**Subject:** Submittal of Replacement Pages to Update the NAC-UMS<sup>®</sup> FSAR from Revision 4 to Revision 5 (Docket No. 72-1015)

**10 CFR 72.48 Evaluation Summary Report**

**NAC-UMS<sup>®</sup> Universal Storage System  
(Docket No. 72-1015)**

PROJECT 412 DRAWING 502 REV 6  
SCALE FULL REVISION NOTED SH 1 OF 6

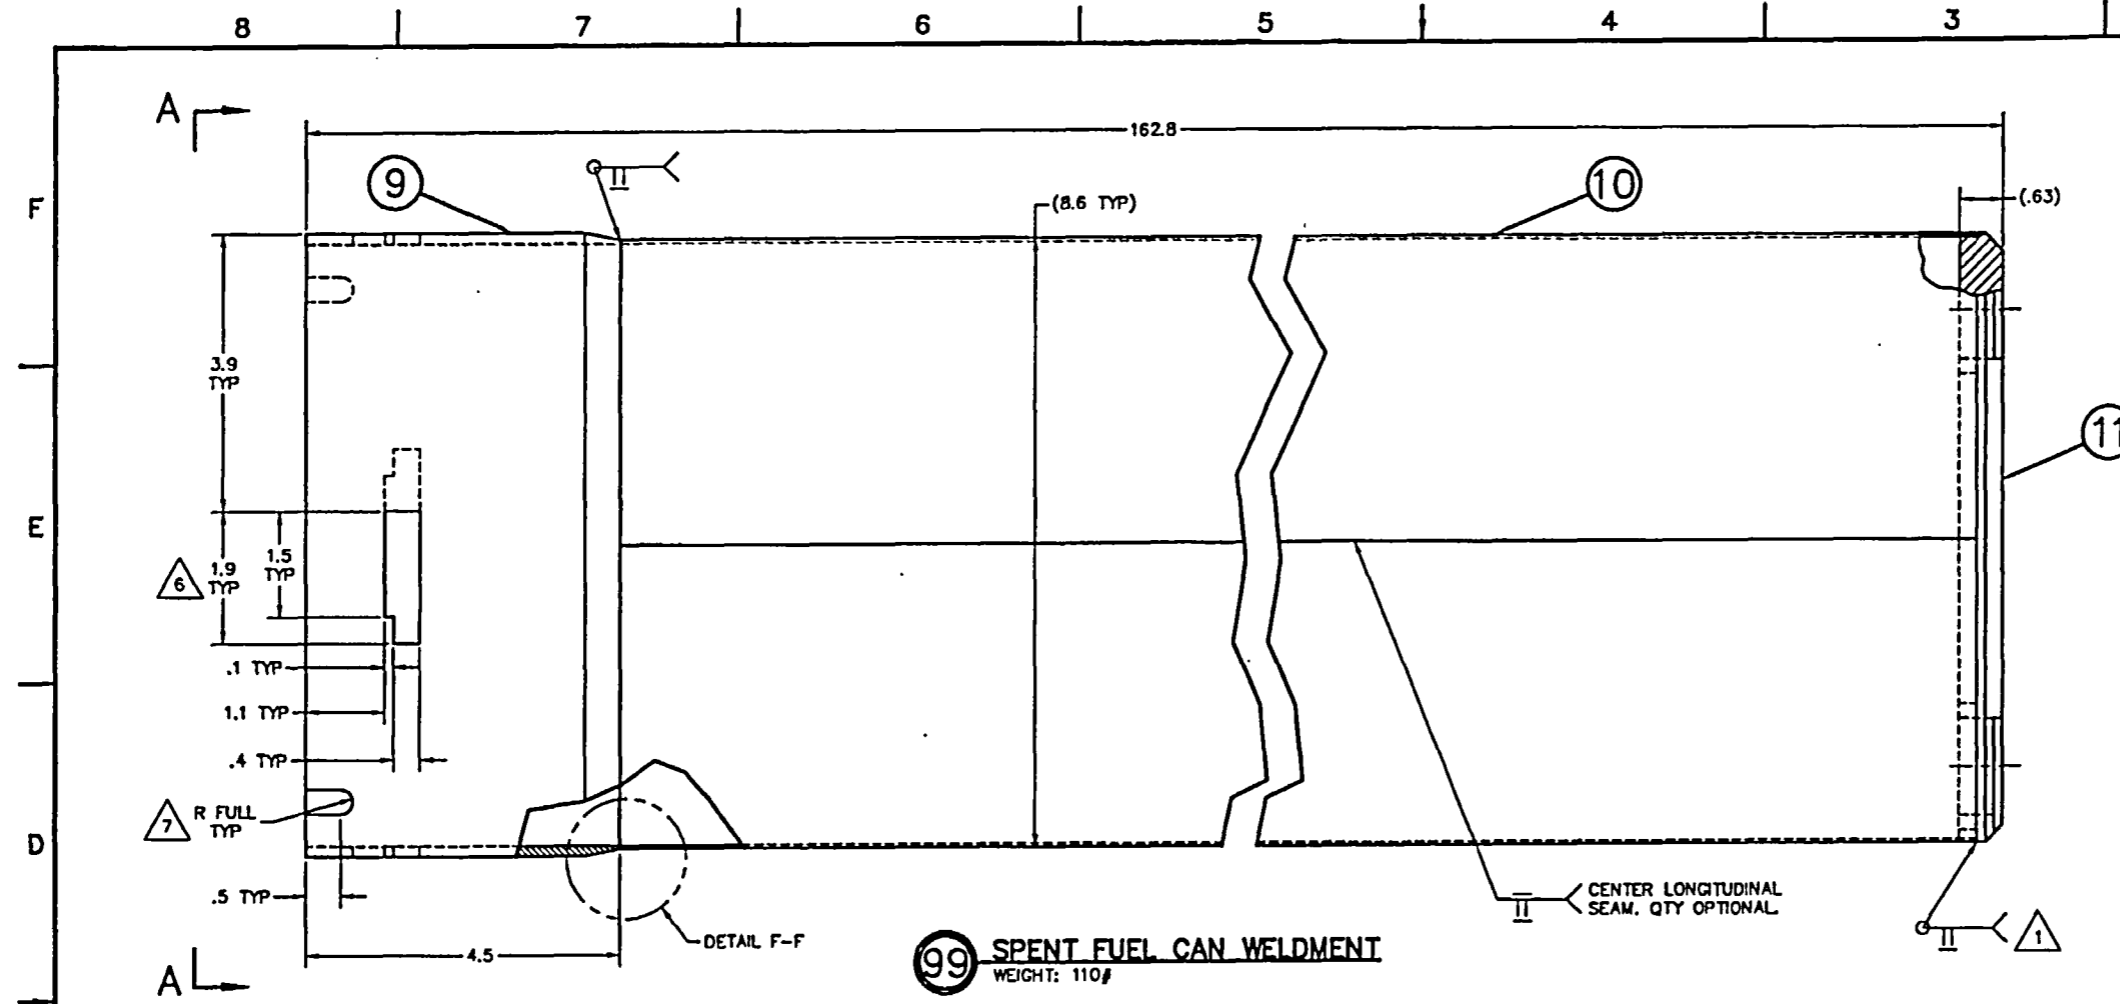
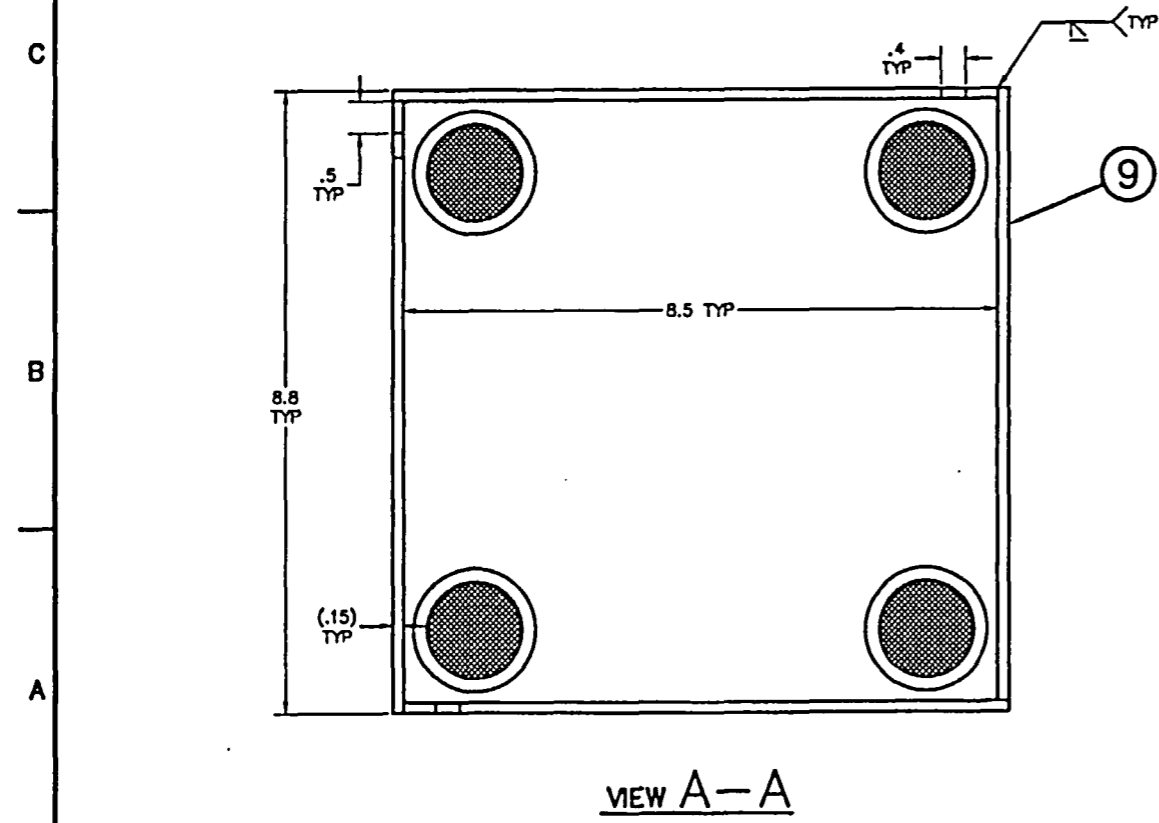
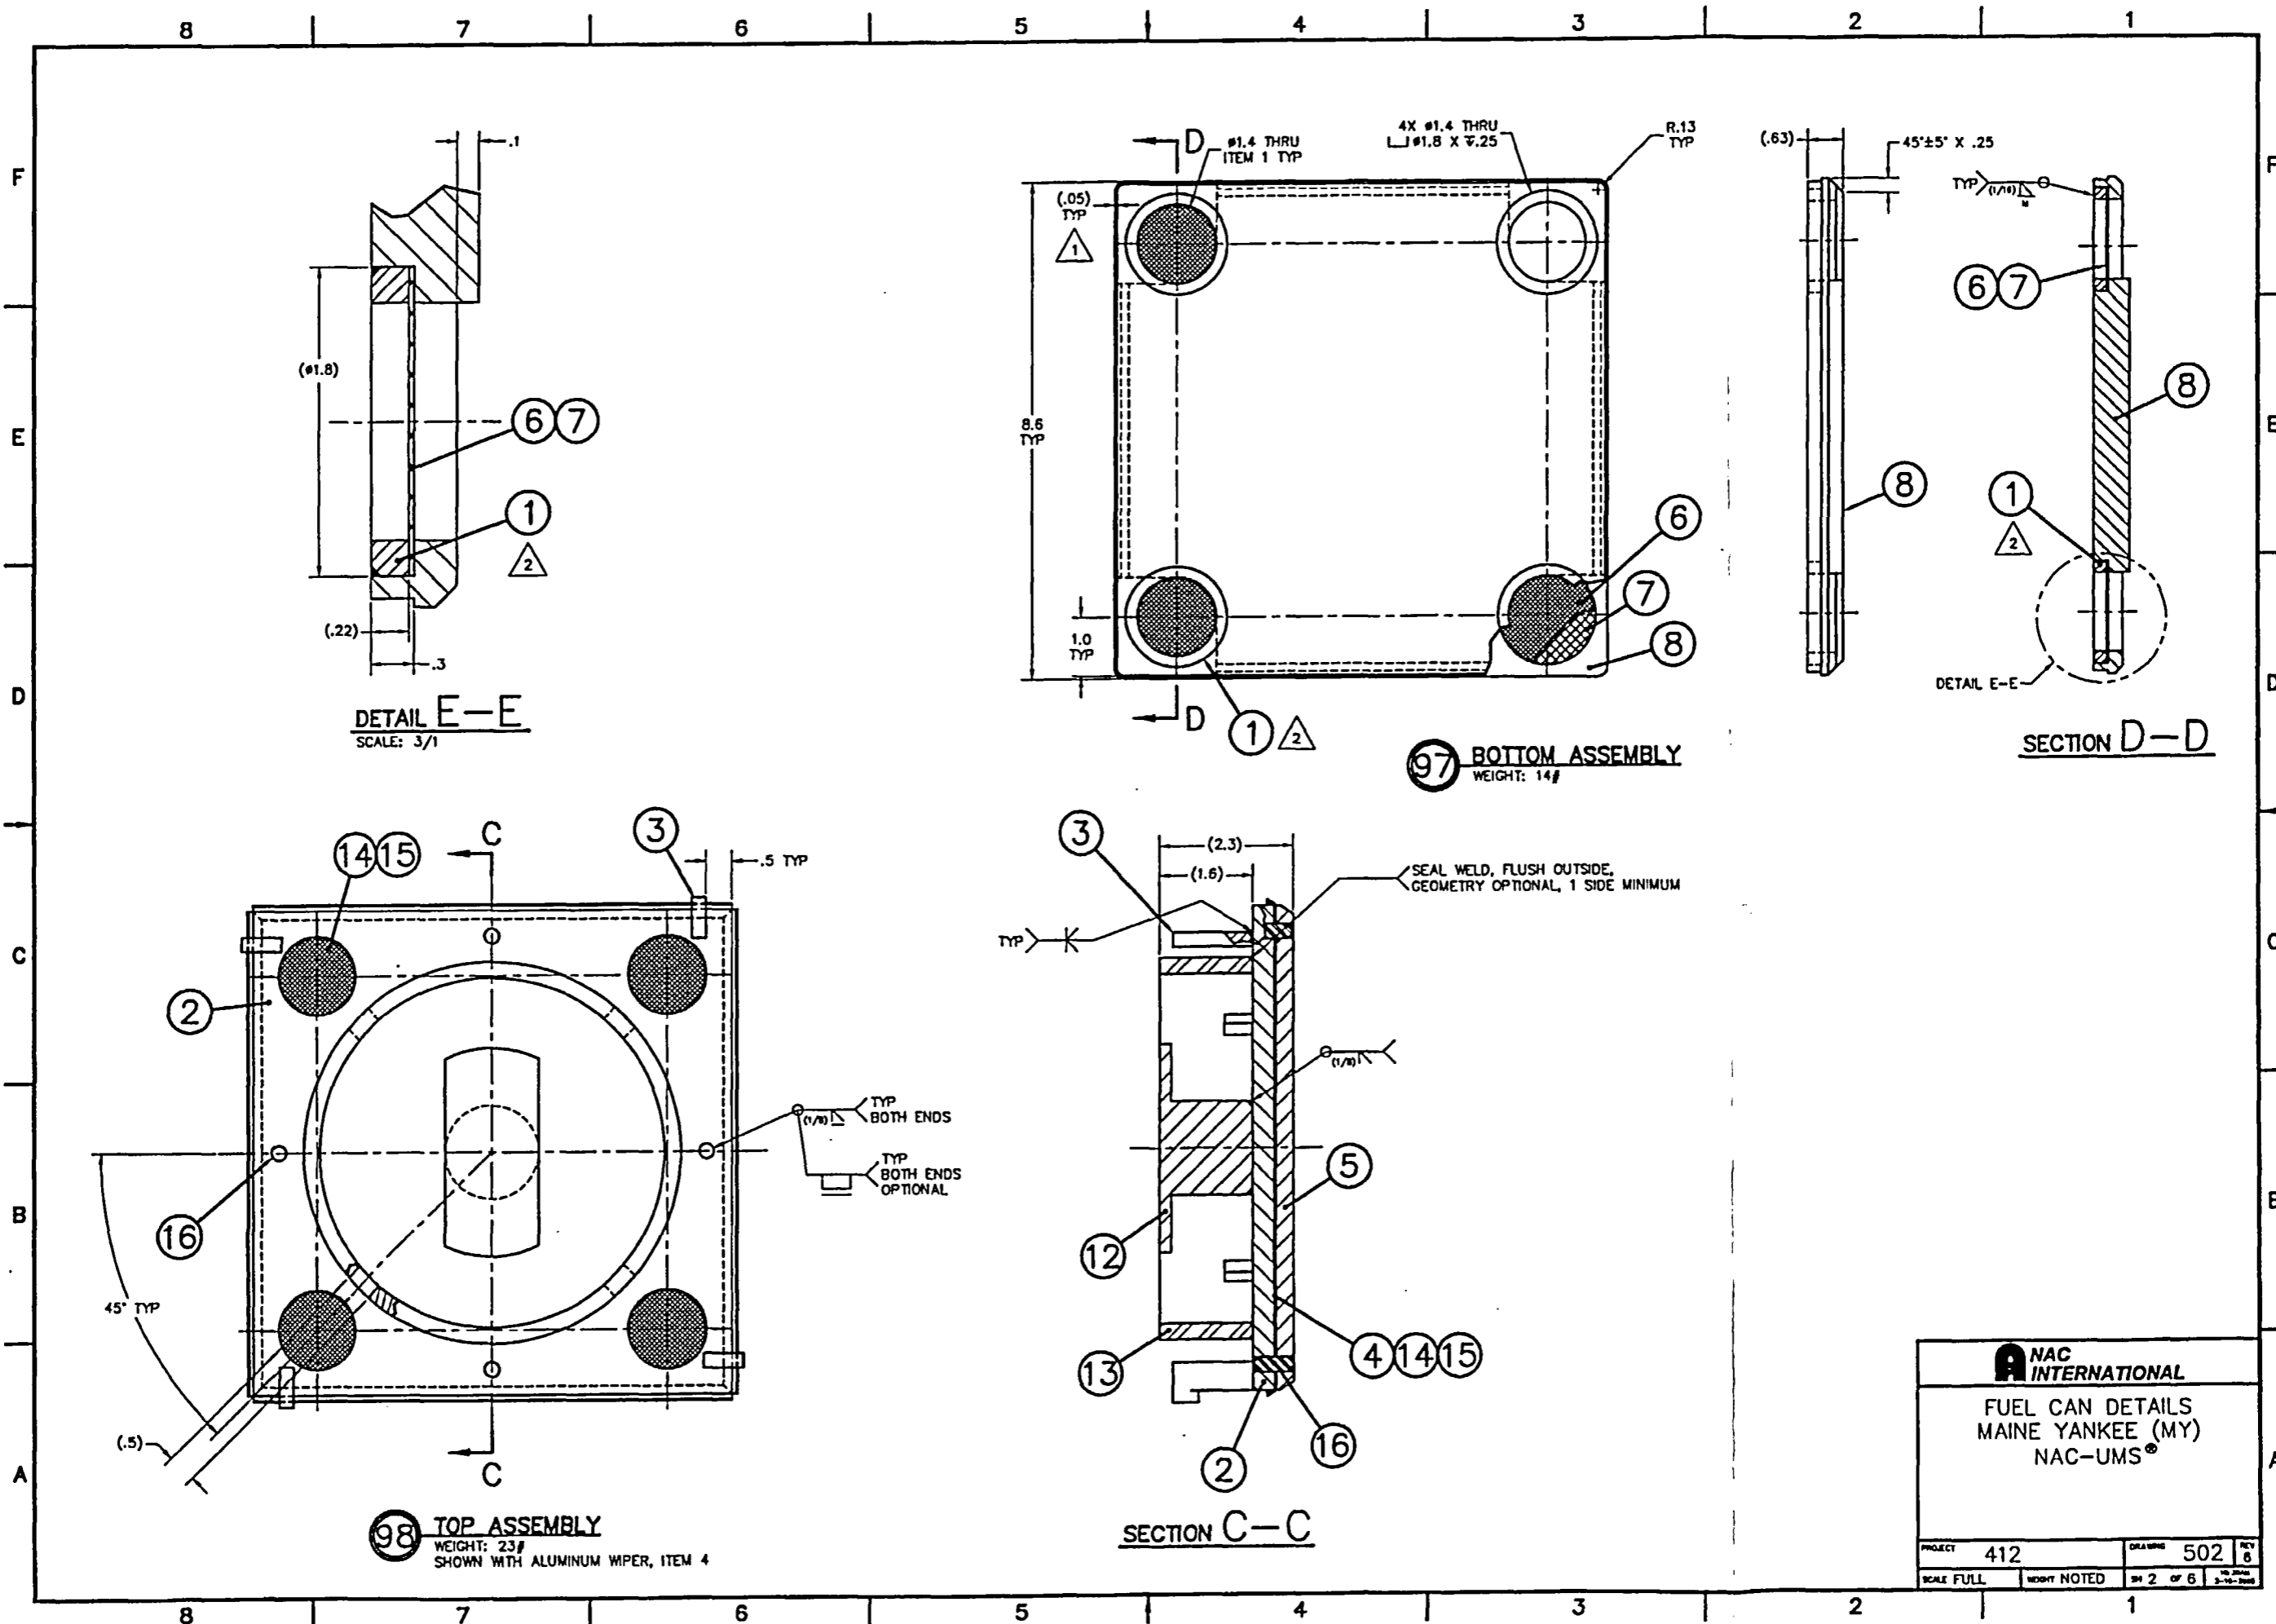
1. Added Delta Note 10 to Item 4, Wiper, "Minor edge surface and/or dimensional deviations are acceptable for Item 4, Wiper."
2. Deleted Detail B-B and callout on Sht 4 of 6, Zone A3 & D1.

The wiper is used to ensure that particles from damaged fuel assemblies stay inside the damaged fuel can. The surface finish and the exact profile/shape of the edge are not critical, so long as the wiper fills the gap between the damaged fuel can and the damaged fuel can lid to block that escape path. These changes have no impact on the performance of each component and/or the overall system functionality. With this DCR(L), the drawing will bound all the final as-built conditions noted in the site documentation packages for the Maine Yankee project.
